**This Addendum contains 4 Pages and 11 Attachments.**

The following information supplements and/or supersedes the bid documents issued on: October 12, 2018

**Tender:** **Base Building Upgrades - Floors 3, 4, 6, 7, 8 & 9**  
**Sherwood Place: 1900 Albert Street, Regina SK**

**Unit Price #1: Refer to Roller Shade Schedule: Section 12 21 16**

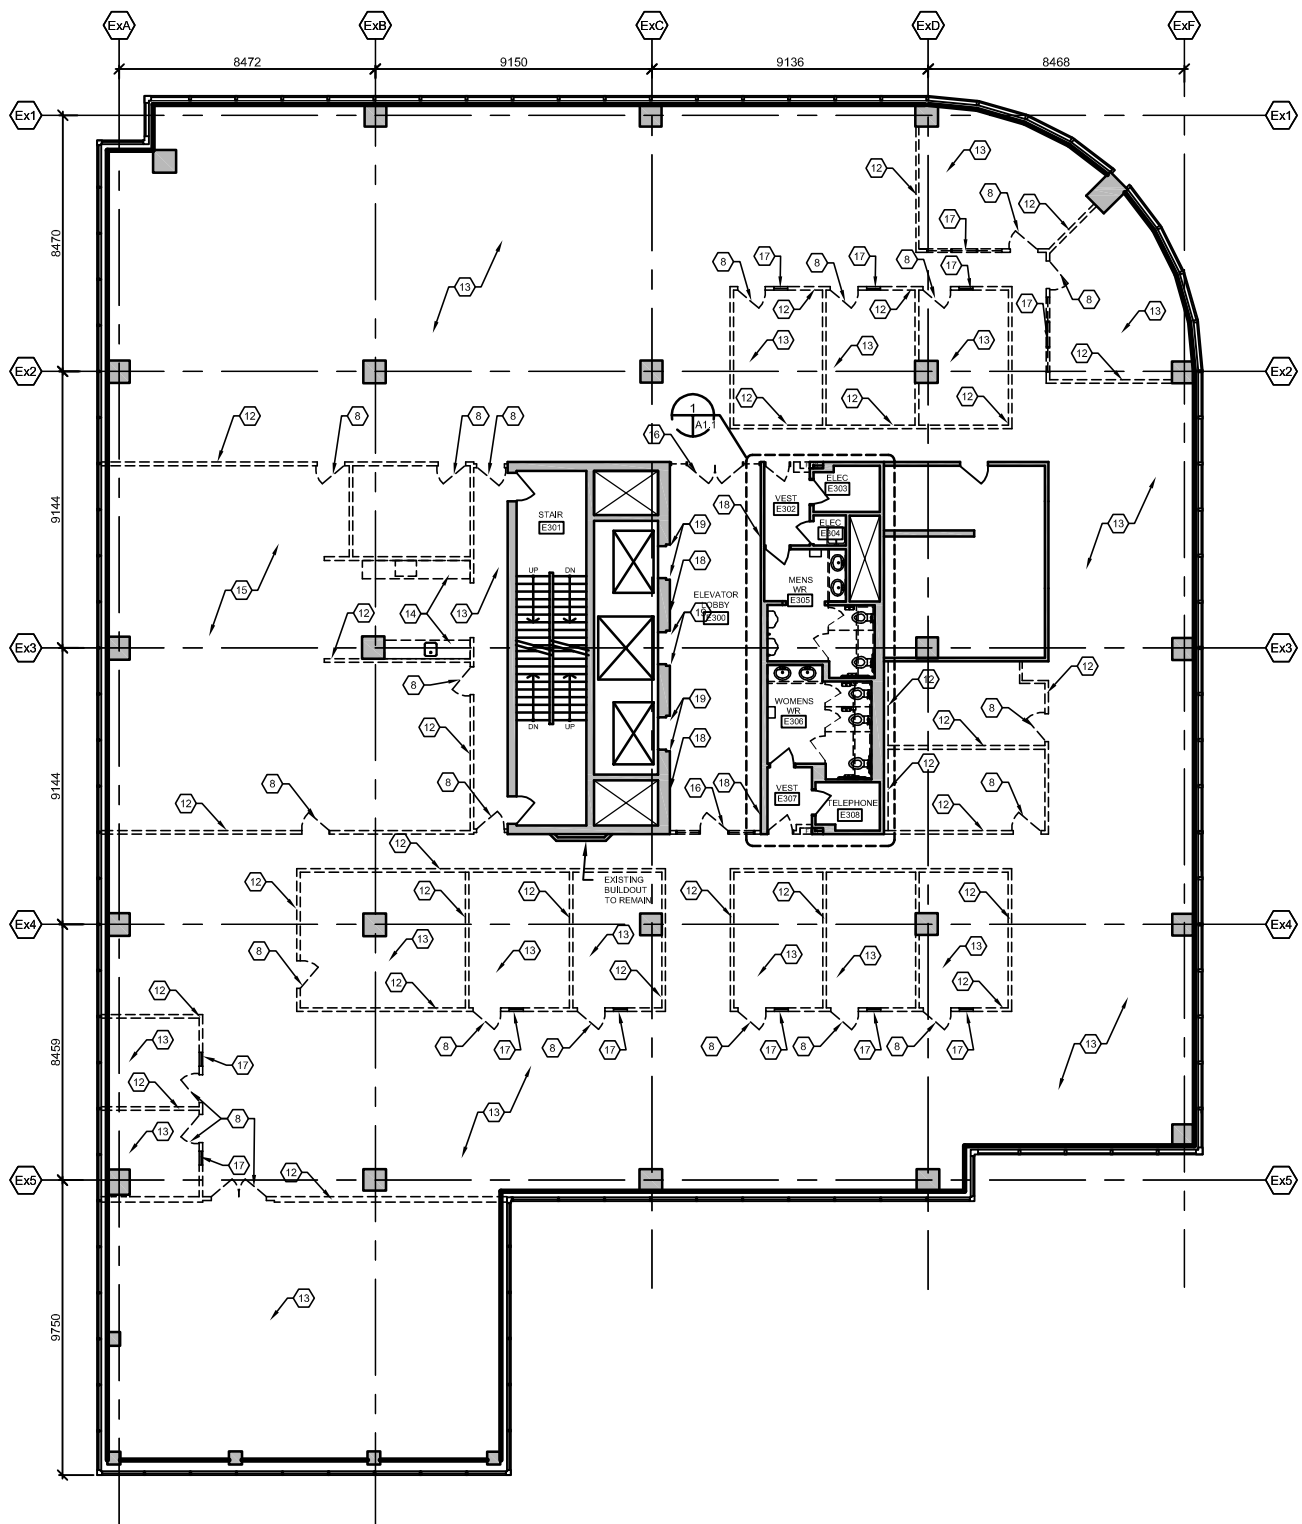
Provide a value to supply and install one (1) of each of the following roller shades:

<b>PROJECT</b>	SHERWOOD PLACE RENOVATION	<b>DRAWN BY</b>	NG	<b>DRAWING NO.</b>
		<b>SCALE</b>		
<b>TITLE</b>	9TH FLOOR DEMOLITION PLAN	<b>DATE</b>	2018-11-01	
		<b>FILE NO.</b>	1837

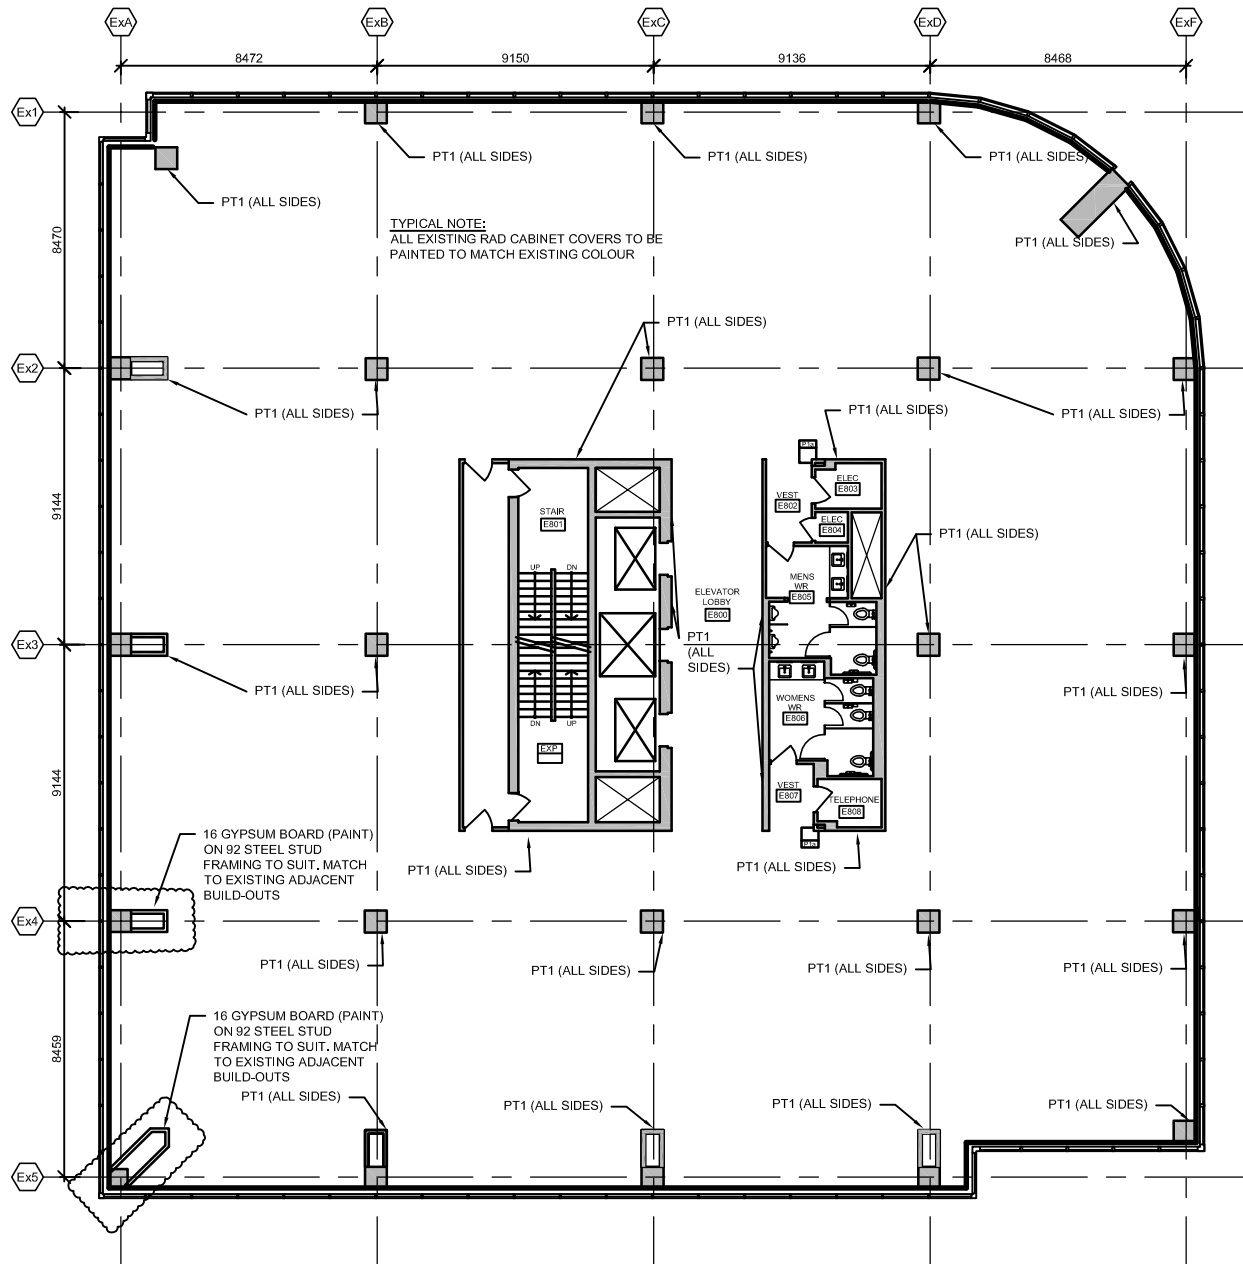
1.5 **Refer to attached Sketch AD03-A2: 9<sup>th</sup> Floor Demolition Plan**: for additional demolition on the 9<sup>th</sup> floor.

1. Contractor to remove existing built-in boardroom table and all associated cabling buried within.

2. Contractor to remove existing gypsum bulkhead and all associated mechanical and electrical fixtures/components:

3. Contractor to remove existing rectangular gypsum board bulkhead in elevator lobby.
